## North Shore Geo, PLLC

June 16, 2023

Subject: **GEOTECHNICAL REVIEW  
STATE OF WASHINGTON DEPARTMENT OF NATURAL RESOURCES (DNR)  
FOREST PRACTICES APPLICATION (FPA) NO. 2617912  
"PARCHED" TIMBER SALE  
CLALLAM COUNTY, WASHINGTON**

Figure-1: Geologic Maps with My Red Feature Numbers; Upper is Original and Lower is Fig. 1 of GMPH with Unit 1

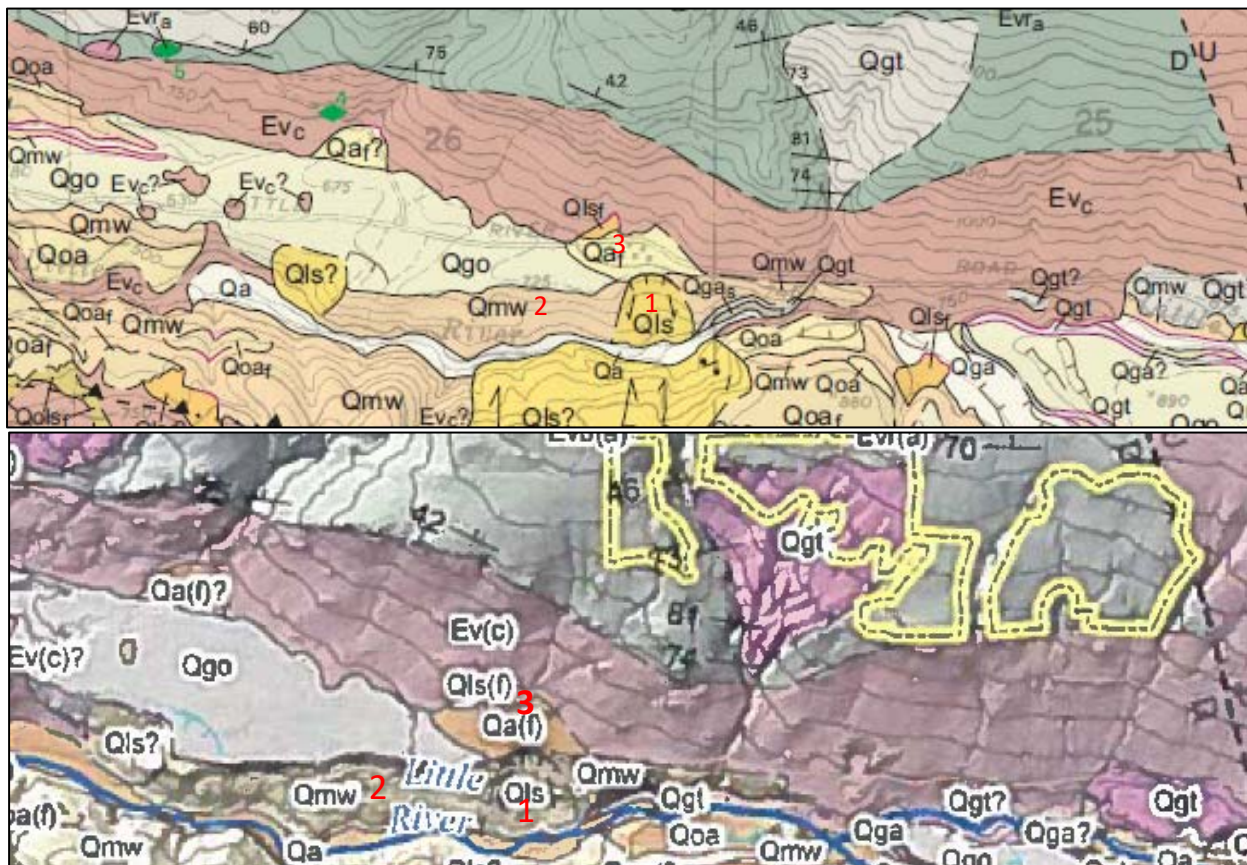
1. Feature 1 (Red Number 1). I was only able to see this feature from Little River Road due to private property access restrictions. It is mapped as a Quaternary landslide (Qls, with relatively-high certainty due to lack of a question mark). This feature is consistent with a DSL, which is considered a RIL per the DNR Forest Practices. The GMPH discusses it on pages 2-4 and in Image 1. The GMPH concludes that less than roughly 20% of the feature from the geologic map is an active glacial DSL, and delineated a topographic groundwater recharge area (TGRA) which does not extend to Unit 1. The GMPH does not mention that the alluvial fan (Qa<sub>f</sub>) feature on the uphill / scarp side of the Qls contains a residential development which is associated with the recent (certainly since the time of timber harvest) road grades and land modifications (buildings are gray boxes). Active fault traces are mapped on the geologic map along the south edge of figure-1 and also roughly parallel to Little River Road (just west of the left edge of the image, but recent studies have extended east through the entire image as I show in my figure-4).

The limits of the Qls / DSL with my red number 1 for feature 1 is much easier to see on the upper image in figure-1 compared to the lower image in figure-1. In my figure-2 below (Fig. 3 of the GMPH), the DNR shows what they consider to be active glacial DSLs as light-yellow areas, with a blue dotted region as the corresponding TGRA for their reduced size (roughly 20%) of feature 1 / Qls / DSL. The larger orange outline area is my feature 1 / Qls / DSL on the geologic map with my very approximate TGRA outlined in light blue. The area northwest of the larger orange area and south of Little River Road is the residentially-developed area that also includes the private road which the DNR finds is responsible for the “deep-seated slump.” This road grade ascends the steep river bluff from the “slump” area near the river up to the northwest edge of the Qls / DSL / orange area. It appears to me that there are other DSLs in this bluff slope in the area of the private road. The DNR determination that the rest of the Qls / DSL / orange area is entirely “intact terrace” does not appear to me to be adequately supported by evidence and appears otherwise in light distancing and ranging (LiDAR) imagery. I discuss feature 2 and my very approximated TGRA (an official TGRA was not included in the GMPH) below my figure-3.

- Qls / Deep-seated slump / feature 1: explain lack of fault discussion and expand DSL area to include uncertainty of “intact terrace,” particularly due to potential adverse effects on infrastructure, residences, and delivery potential to Little River.
- Active glacial DSL / feature 2 immediately west of feature 1: delineate TGRA for this DSL and consider expanding the DSL area to include scarps extending above terrace.
- “Landslide debris fan (Qls<sub>f</sub>)” / Feature 3: discuss this feature and explain why it was not reviewed, or review it.

Figure-2: GMPH Fig. 3 with My Added Orange Outline of Geologic Map DSL / Qls and Light Blue Outline of Very Rough Estimate of TGRAs for Features 1 and 2

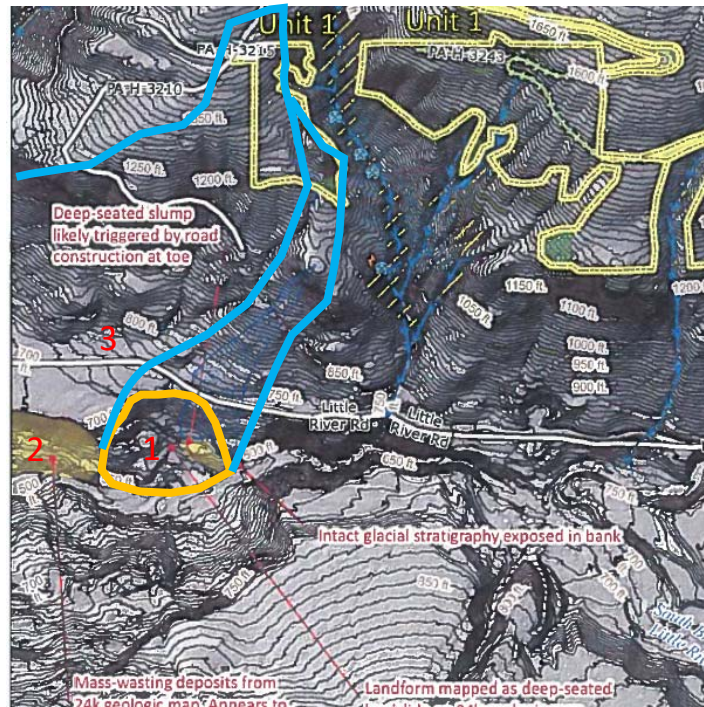
2. Feature 2 (Red Number 2). I was not able to review this feature in the field due to private property access. This feature is visible as delineated by the DNR in my Figure-2 above (Fig. 3 from the GMPTH) and my rough approximation of the DNR’s delineation is shown above in my Figure-3. The GMPTH text does not mention this feature, but in its Fig. 3 is called out as: “Mass-wasting deposits from 24k geologic map. Appears to be deep-seated landslide in LiDAR.” The materials in this area appear to be glacial based on the geologic map, the GMPTH, and appear to be “active.” **As such, feature 2 is likely an active glacial DSL, which is a RIL, with a TGRA that is also a RIL. A TGRA for feature 2, which appears that it would include Unit 1 and at least one residential property, was omitted from the GMPTH.**

It appears to me that several scarps associated with this feature extend up onto the terrace and show significant displacement of the glacial terrace, implying that the area the DNR shaded yellow on their Fig. 3 should be enlarged significantly.

**Figure-3: LiDAR Imagery with Light Yellow DNR DSLs, Rough Yellow Unit 1 Outline, My Feature Numbers, My Landslide Scarps in Red, Orange Geologic Map DSL / Qs, Black Ts for Terraces, and Light Blue Outline of Very Rough Estimate of TGRAs**

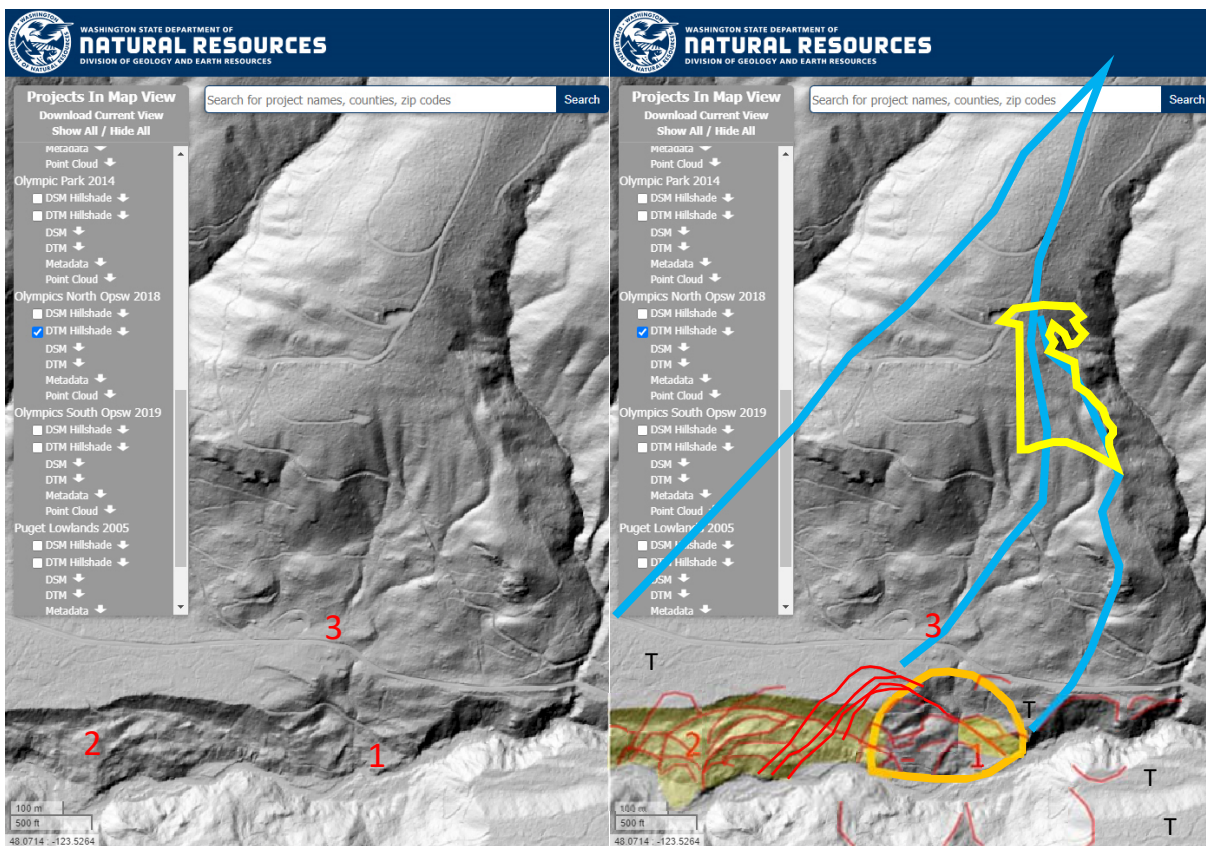
My Figure-3 below is a comparison of “bare-earth” LiDAR from the DNR LiDAR Portal with my annotations. I find that these images from the DNR website provide a third look at this area in comparison to the two images on page 3 of the GMPTH, although the digital quality of the FPA PDF document is low and many features are difficult to see clearly. **Rather than finding the topography dominated by intact terraces as the GMPTH did, I find the terrain to be dominated by DSL activity** related to river scour and channel migration, and apparent groundwater-driven landslides in glacial or post-glacial sediments. I have included a black letter T in areas that appear to me to be intact terraces. In Figure-3 I have also approximated the locations of Unit 1, the DNR-identified glacial DSLs, landslide scarps, and TGRAs. The very dark shaded area east of feature 1 appears to be actively scoured by the River and appears to have potential to expand into the road. This feature appears as though the proposed timber sale would increase runoff and groundwater here, which would decrease stability. Instability here directly and adversely affects residences, Little River Road, and Little River.

Figure-4: 2021 Fault Study Referenced in Aldwell EGRA with Red Fault Traces, My Hand at Quarry Location discussed in Aldwell FPA, Orange Feature 1, Yellow Shaded Feature 2, Yellow Outlined Unit 1, and Red Numbers for Features 1-3

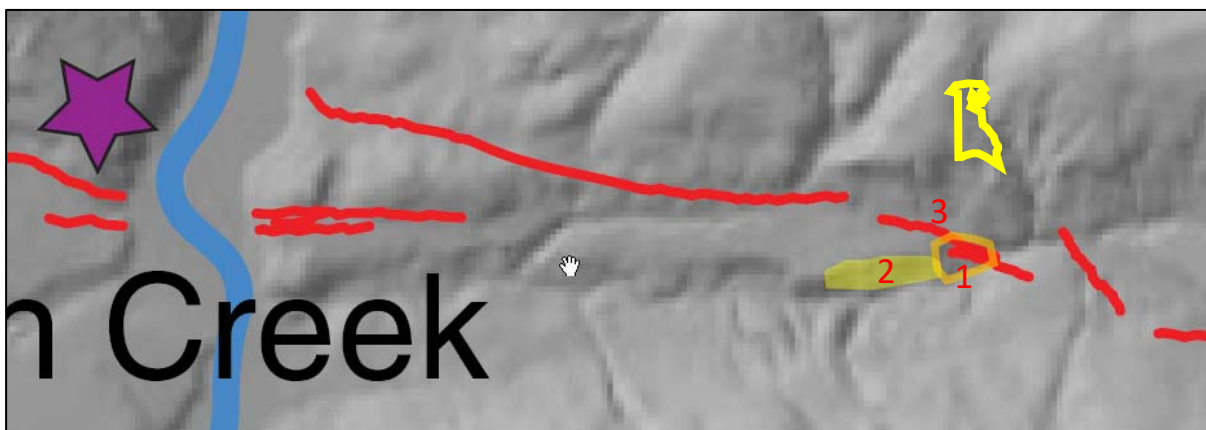
**4. Active Faults.** The immediately-adjacent “Aldwell” timber sale (FPA 2617563) included an engineering geologic risk assessment (EGRA) report by the same author as the GMPH for the subject FPA, which included significant discussion of active fault traces (activity at 1, 3, 7, 8.5, and 11 thousand years ago with Magnitude 7-7.5 earthquakes) of the “North Olympic fault zone” or “Lake Creek-Boundary Creek fault.” The same 2021 reference from the Aldwell EGRA (*Elizabeth R. Schermer, Colin B. Amos, William Cody Duckworth, Alan R. Nelson, Stephen Angster, Jaime Delano, Brian L. Sherrrod; Postglacial Mw 7.0–7.5 Earthquakes on the North Olympic Fault Zone, Washington. Bulletin of the Seismological Society of America 2020;; 111 (1): 490–513. doi: <https://doi.org/10.1785/0120200176>*), and a 2019 reference (*Duckworth, Cody, "Slip and strain accumulation along the Sadie Creek fault, Olympic Peninsula, Washington" (2019). WWU Graduate School Collection. 896. <https://cedar.wvu.edu/wwuet/896>*) from the 2021 reference show active fault traces crossing my “feature 1” and my “Feature 3” discussed above and trace very close to the top of my “feature 2.” Figure-4 and figure-5 below include images from the 2021 and 2019 documents with my annotations. **The DNR did not discuss active faults in the GMPH and their presence within the discussed active DSLs.**

Figure-6: GMPH Fig. 4 with My Annotations

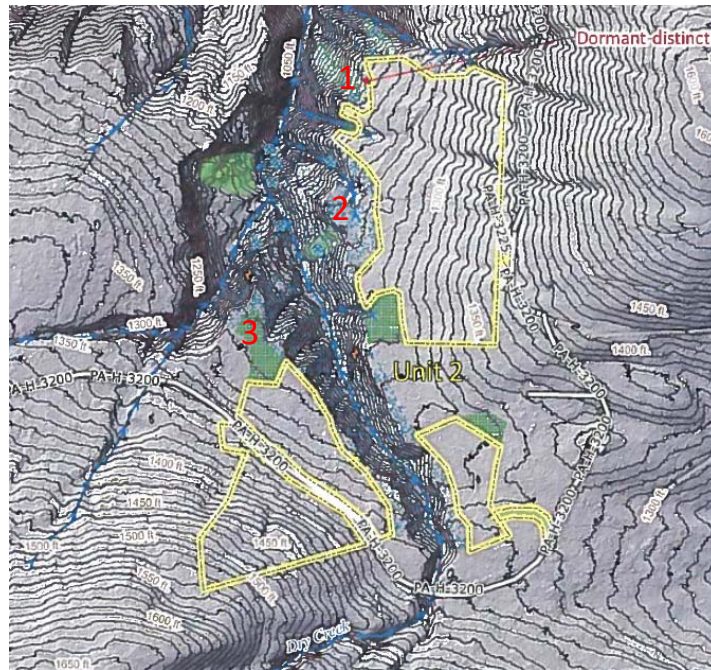
In Unit 2 I reviewed only the northwest and northeast portions in the field, including the Creek bluff slopes and adjacent upland areas. At the northwest corner of the northeast portion of the unit (marked with a red 1), I observed the bedrock DSL discussed on page 2 of the GMPH, including the old timber sale boundary markers on the body of this DSL which have been moved uphill to above the head-scarp. I do not understand the GMPH discussion here. The geologist would have approved harvesting part of the slide body and head-scarp, but the forester excluded it? If it was to be included in the sale, would the sale then be a type IV special? I agree that the head-scarp and upper part of the slide body appear dormant-distinct, but I would anticipate uphill-propagation of the Creek scour at the toe of this slide as category E or a potential for future instability. This DSL appears to have been caused by Creek scour at the toe and groundwater, both of which will be increased by this FPA. The FPA activity map shows a strange overlap of the riparian management zone (RMZ) graphic onto the harvest area that is inconsistent with the GMPH harvest boundary that should be edited.

The area of my red number 2 which is a broad wetland with minimal timber appears to also be a large DSL, with the ridge between the wetland / type 4 stream being the slide block. This slide appears to also be a bedrock DSL, which eliminates the delineation of a TGRA and the harvest boundary would remain in its current location. Timber harvest east / uphill of this area will add major additional surface and groundwater to this area, which will certainly increase erosion in the streams and instability of the stream bluffs, but the forest practices rules allow this.

The LTA on the north edge of the northwest portion of Unit 2, where my red 3 is located, appears to avoid harvesting this narrow ridge between very steep and unstable Inner Gorge and shallow landslide slopes. The shallow landslide (lightning symbol) appears to be on the west side of this ridge. I interpret the east-facing slope adjacent to the shallow landslide to be a DSL. The RMZ in this area seems minimal.

This LTA has experienced major windthrow that appears associated with the recent harvest of the area immediately to the west. The south, east, and west edges of this LTA appeared very wet at the time of my field review, with standing water and saturated, soft soils. There appears to be a north-flowing stream(s) from several culverts in the PA-H-3200 road through a recent harvest area west and south of this LTA through the LTA to these very steep bluff slopes. These conditions appeared similar to wetland conditions and may have contributed to windthrow in this area. The LTA at the northwest corner of the west edge of the unit appears to be covering some very borderline harvest area which appears as though more of it should be bound out of the sale rather than considered an LTA.

- Dormant-distinct DSL / feature 1: explain the discussion of this in GMPTH and clarify the timber sale boundary between FPA maps.
- Northwestern LTA / feature 3: review this area for streams and windthrow hazard in very wet soil conditions, consider the narrow area between shallow landslides, wet soil windthrow, DSLs, and RMZs to be bound out rather than LTA.
